Patent No.: 7,113,873 B2

For: METHOD AND SYSTEM FOR USING
EDDY CURRENT TRANSDUCERS IN
PRESSURE MEASUREMENTS

REQUEST FOR CERTIFICATE OF CORRECTION OF
PATENT UNDER 37 C.F.R. 1.322(a)

AMENDMENT

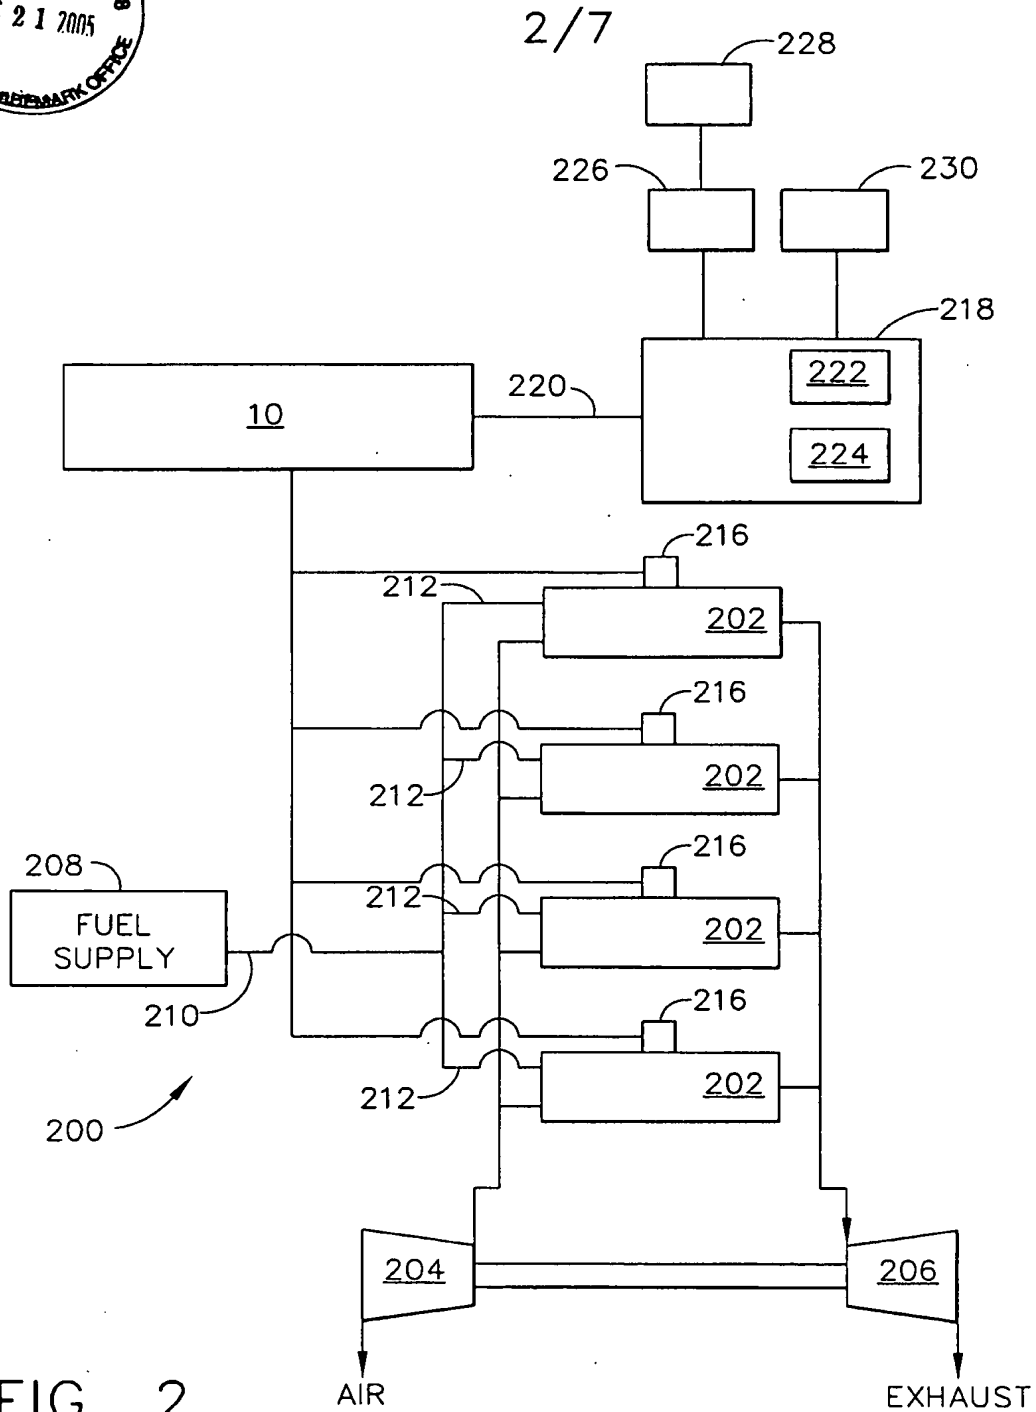
The objections to the drawings under 37 C.F.R. 1.83 (a), is respectfully traversed. Specifically, Figures 1, and 2 have been amended to remove references numbers 82, 86, and 214. No new matter has been added. Replacement sheets for Figures 1 and 2 are attached.
